1ST FLOOR

SARGENTI ARCHITECTS, P.C.

RTM Engineering Consultants, LLC

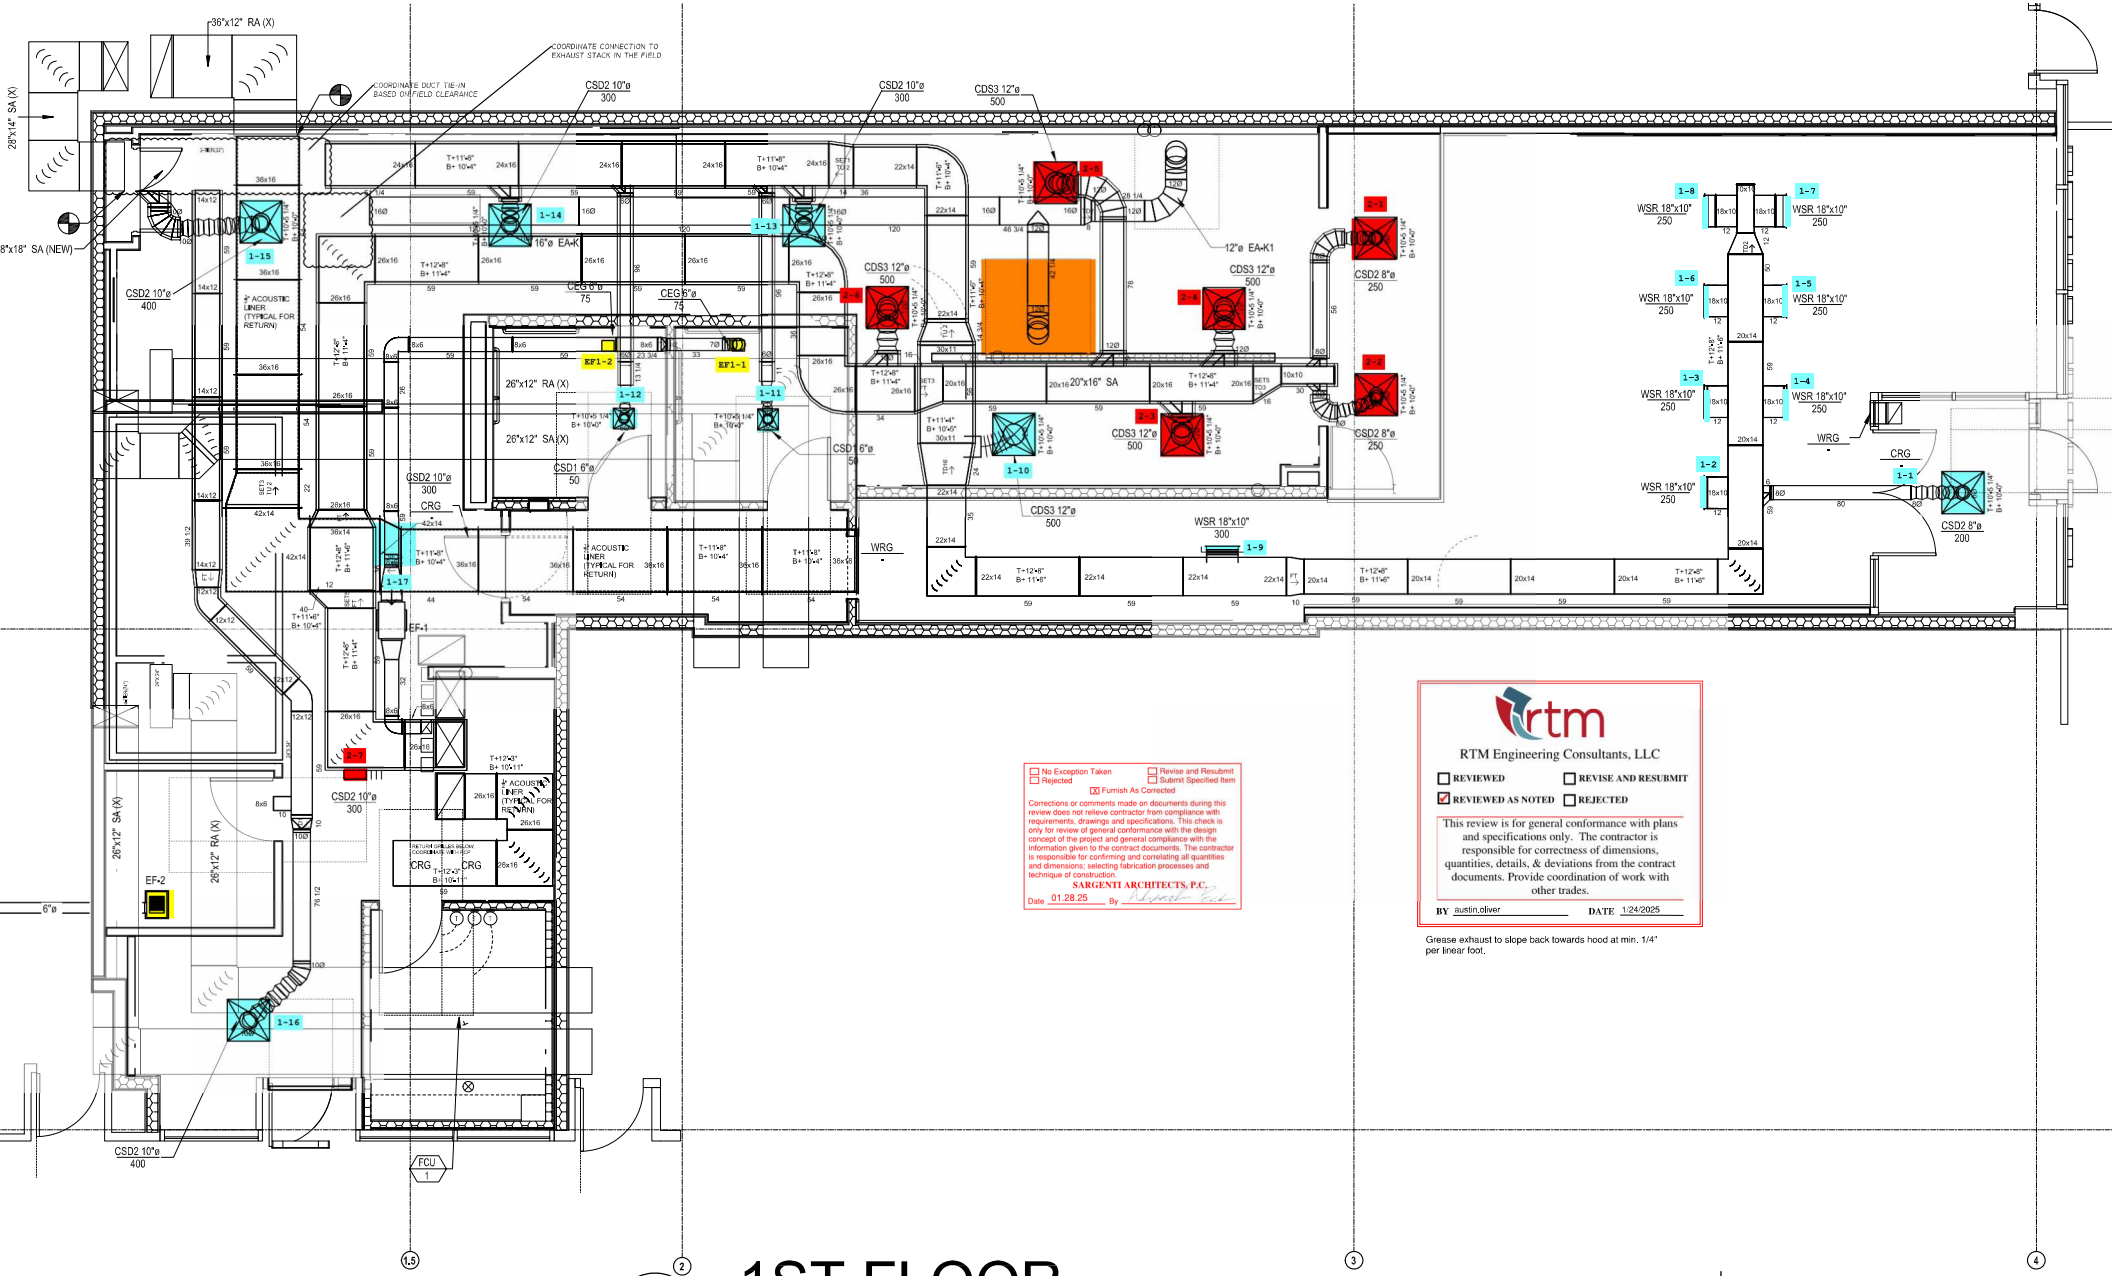
Grease exhaust to slope back towards hood at min. 1/4" per linear foot.
